# Wayzata Planning Commission

Monday, August 21, 2017

**a.) Waytonka East End – 236 Central Ave S and 1101 Lasalle St  
i. Preliminary and Final Plat Subdivision**

**Project Name:** Wayzata Blu  
**Applicant:** Gatehouse Properties Ltd  
**Addresses of Request:** 259, 269 and 275 Lake St E and 339 Barry Ave S  
**Prepared by:** Jeff Thomson, Director of Planning and Building  
**“60 Day” Deadline:** September 17, 2017

**GRADING PLAN**  
**RED PATH COURT**  
**PILLAR HOMES**

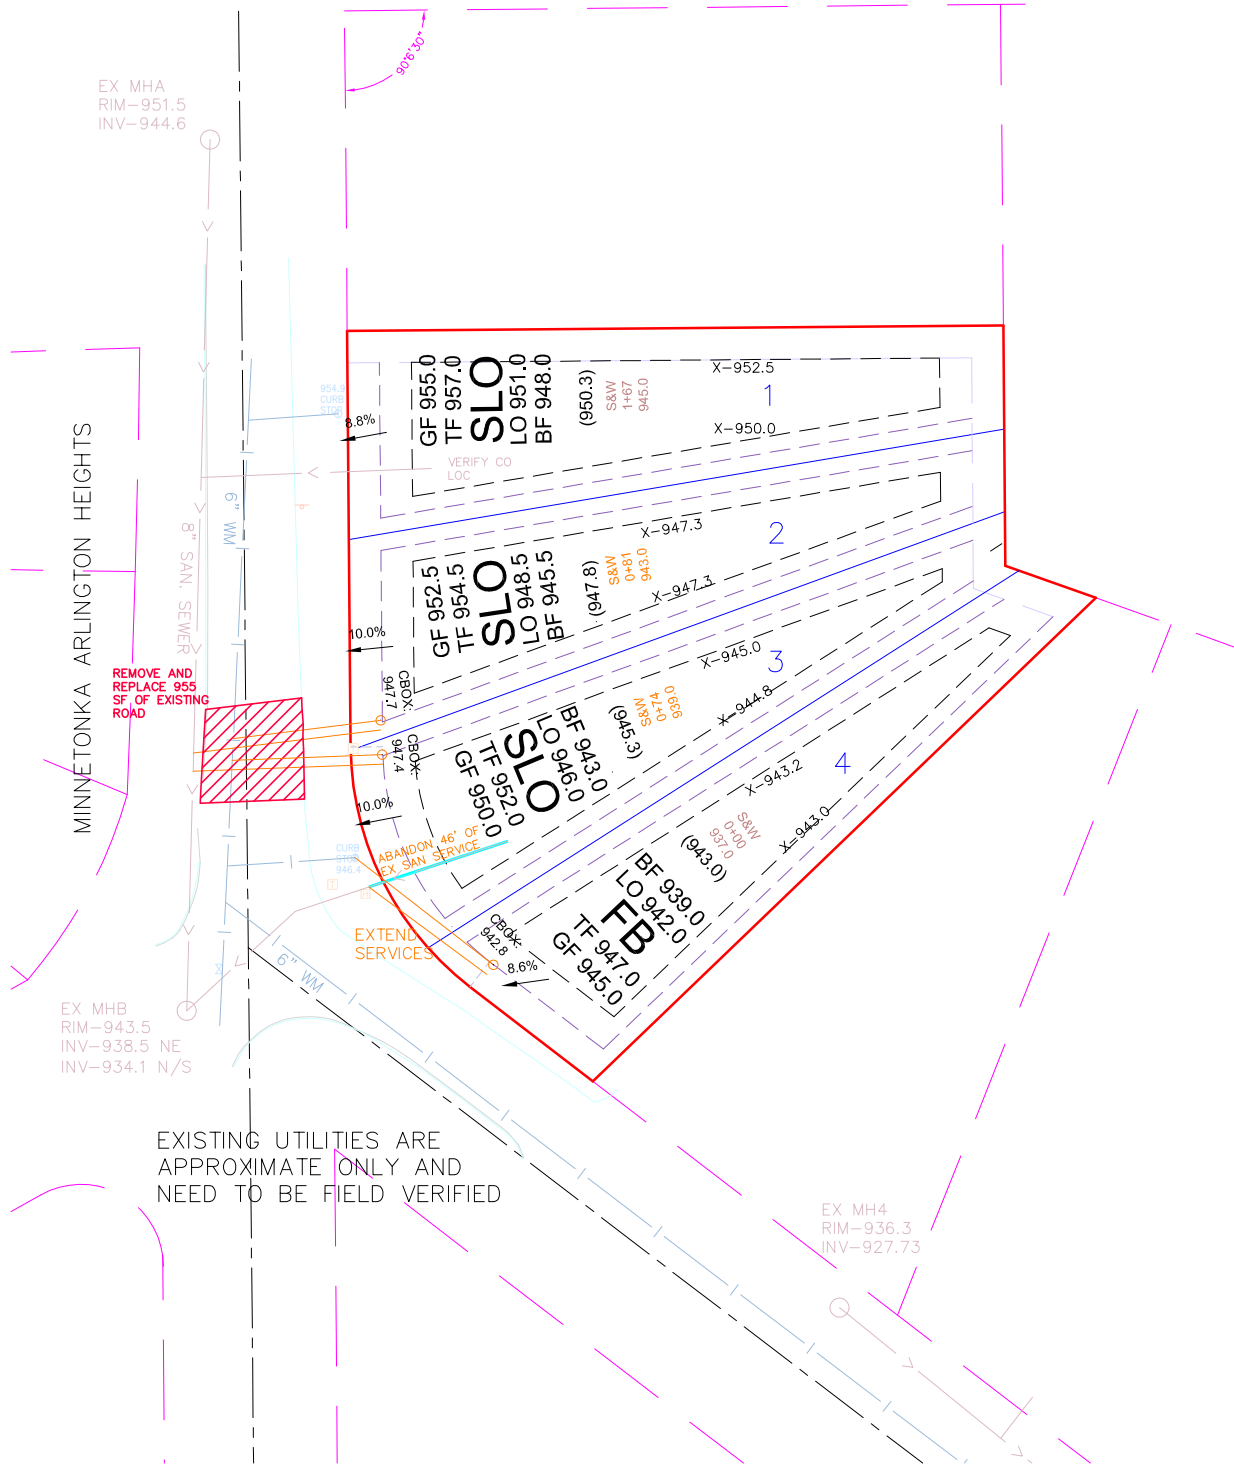
- Provide cut/fill amounts calculated on a per lot and total site basis, and the total change in grade for each lot.
- Revise the grading plan to show drainage arrows and any methods that could be used to direct runoff to the back of the lots and not onto adjoining lots.
- Revise the grading plan to pull the grading limits in to minimize impacts to the root zone, and to ensure the trees on the back of the lots, and the north side of Lot 1 are preserved as shown on the tree plan.
- Review the house pads and grading near tree #300 to see if it can be preserved as intended.
- Provide response to estimated home prices and anticipated building height.
- Review if there is any means of preserving the 3 oak trees (trees #329, 330, 332).

| DRAWING NAME | NO. | BY  | DATE       | REVISIONS                    |
|--------------|-----|-----|------------|------------------------------|
| REDPATH      | 01  | DLS | 08/16/2017 | PLANNING COMMISSION COMMENTS |
